**NRC DISTRIBUTION FOR PART 50 DOCKET MATERIAL
(TEMPORARY FORM)**

DESCRIPTION: Ltr notarized 11-10-75 request for change to Tech Specs re control rod & operational withdrawal limits & furn info re ECCS & with attached Figures 3.5.2-1a2 & 3.5-21....

PLANT NAME: Oconee 1-2-3

Re: Oconee Nuclear Station
Docket Nos. 50-269-270, -287

Figure 3.5.2-1A2

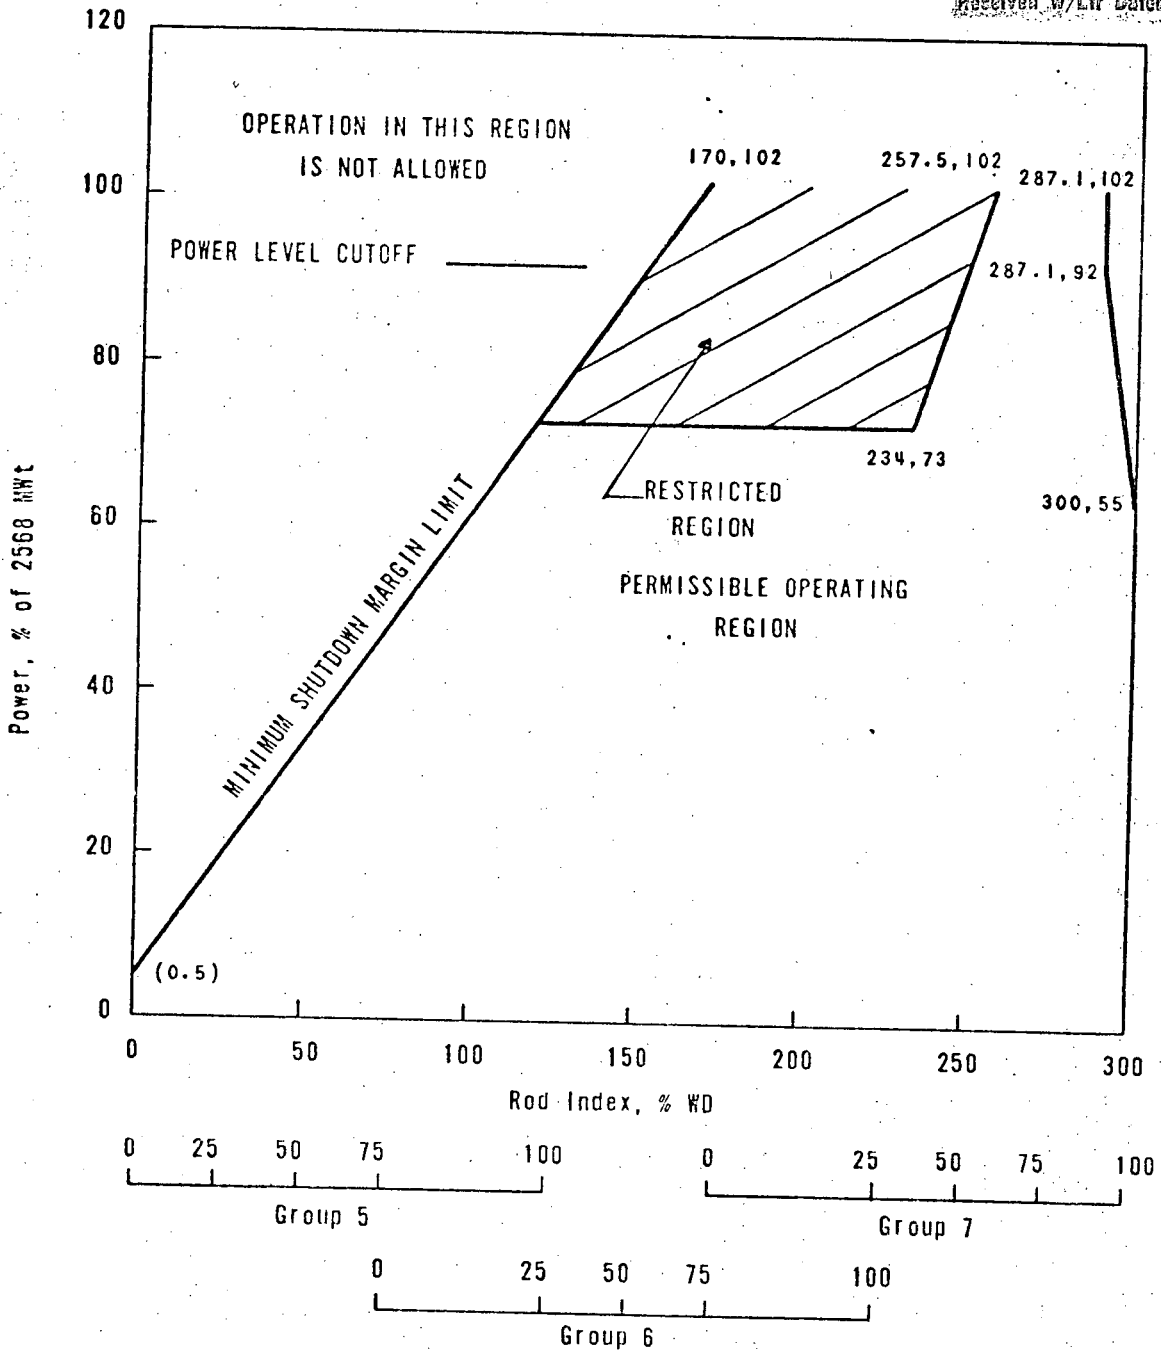
As you are aware, the existing Technical Specifications for Oconee Unit 1 do not include the specification for control rod withdrawal limits (Figure 3.5.2-1A2) that are required to be used toward the end of the cycle, when Group 7 control rods are significantly withdrawn from the core. This specification for control rod withdrawal limits was excluded because the Technical Specifications based on the ECCS Final Acceptance Criteria were expected to be approved before the time that the limits would be required; and, therefore, the limits that meet both the Interim Acceptance Criteria and the Final Acceptance Criteria were not submitted.

To enable continued full power operation of Oconee Unit 1 in the event Commission approval of the proposed Technical Specifications based on the Final Acceptance Criteria is not granted by December 1, 1975, Duke Power Company submits herewith (pursuant to 10CFR50, §50.90) proposed Technical Specifications for control rod and operational

power imbalance limits (Figures 3.5.2-1A2 and 3.5.2-3A) which meet both the IAC and FAC. In the event that the Commission is unable to approve the proposed Technical Specifications based on the FAC by December 1, 1975, we request that approval of the Oconee 1 Technical Specifications for control rod and operational power imbalance limits, which meet both the IAC and the FAC, be granted no later than December 1, 1975.

Attached are the control rod position limits for four-pump operation applicable to the period after 245 ± 10 EFPD (Figure 3.5.2-1A2) and the operational power imbalance limits (Figure 3.5.2-3A) which meet both the IAC and FAC for Oconee Unit 1.
